ADDENDUM NO. 1

**HANOVER COMMUNITY SCHOOL CORPORATION - NEW RESOURCE
CENTER AND RELATED WORK
Cedar Lake, IN 46303**

This Addendum consists of page ADD 1-1 and attached Addendum No. 1 from Gibraltar Design dated May 27, 2021 and consisting of 5 pages and 48 drawings.

© GIBRALTAR DESIGN
SHEET
EP101

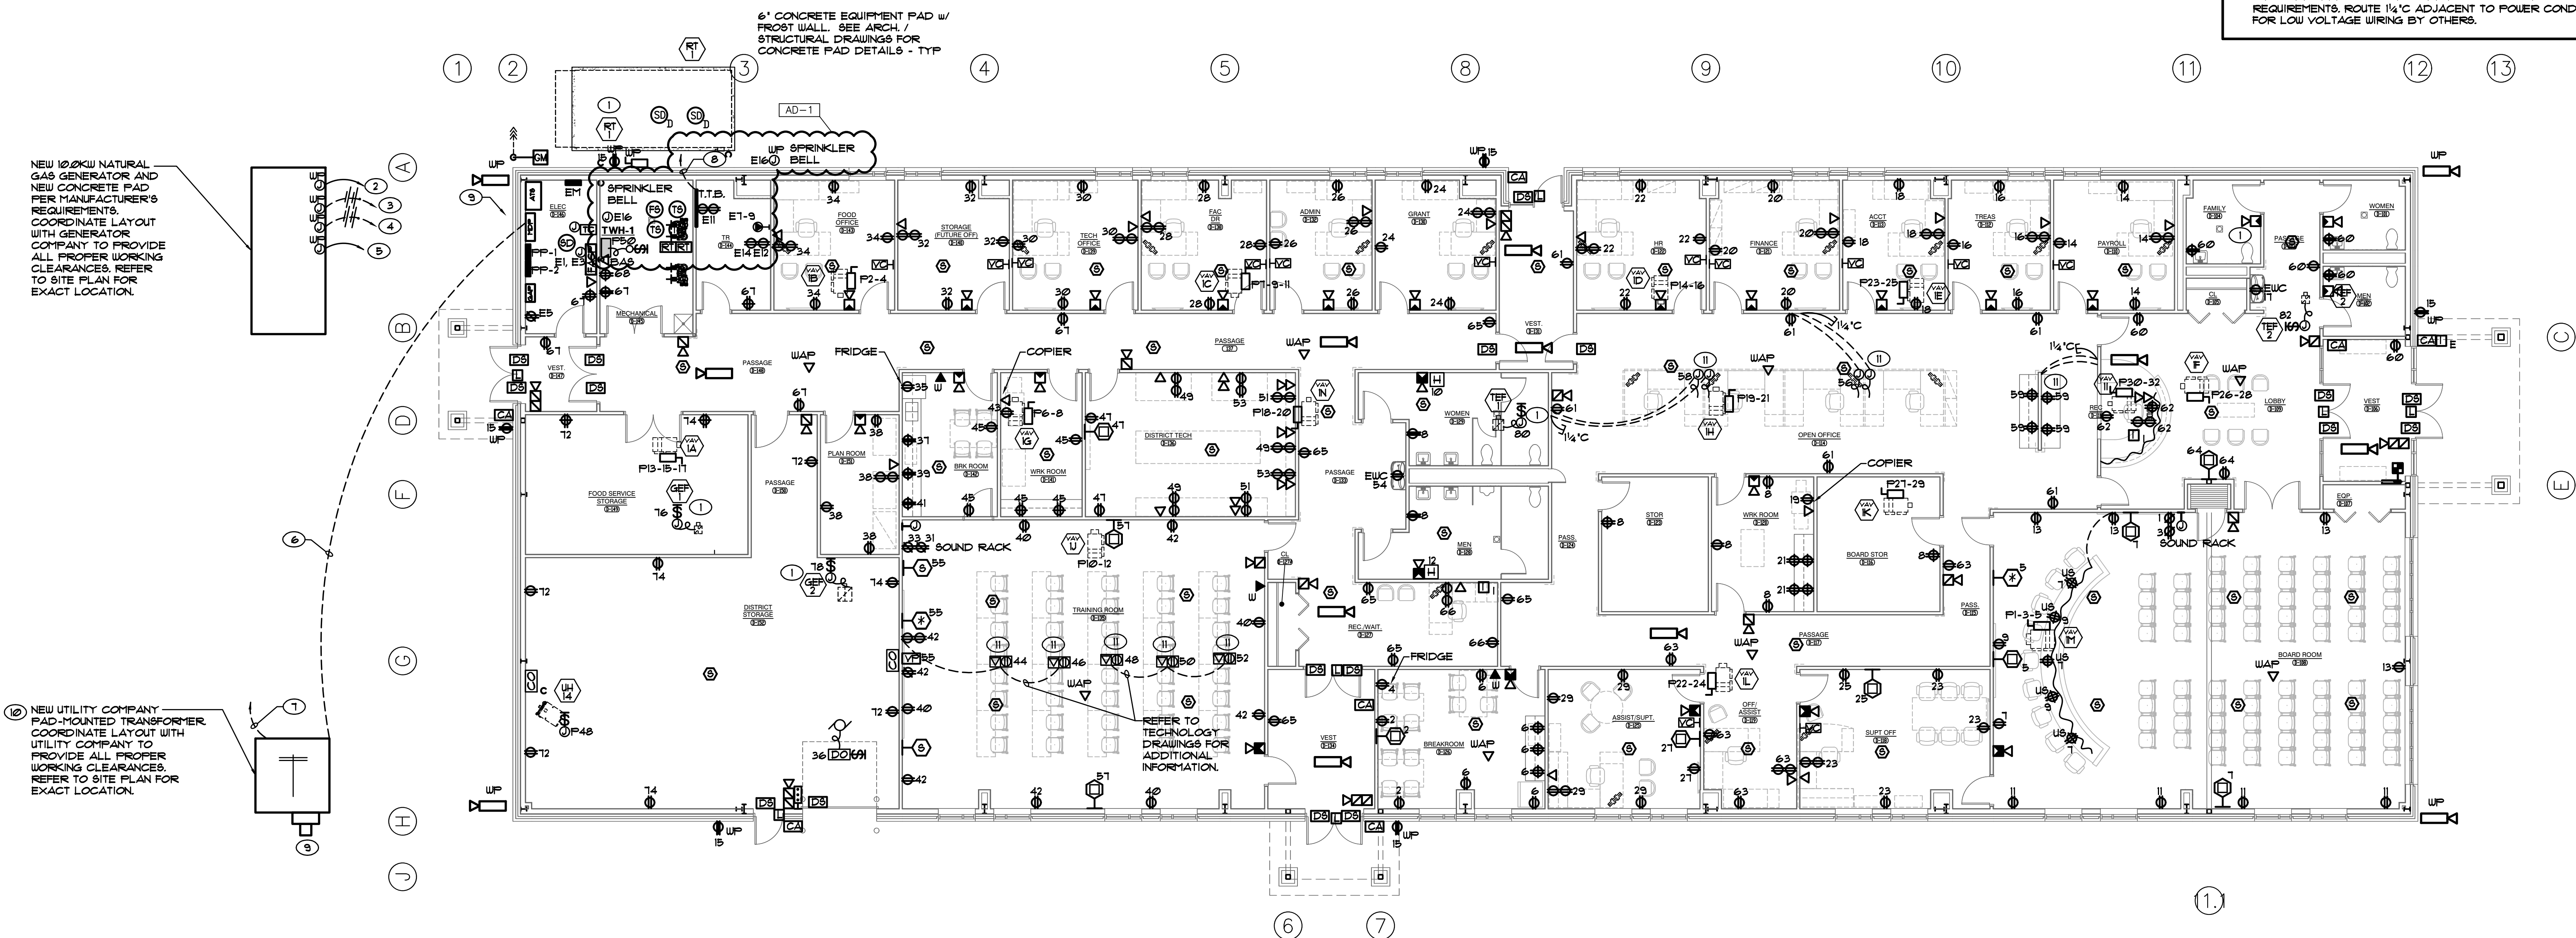
31. Sheet EP-101

- A. REVISE Power device and equipment locations, quantities and circuiting. Refer to revised drawing for additional information.
- B. ADD Notes for Alternate #2 to roof top units.
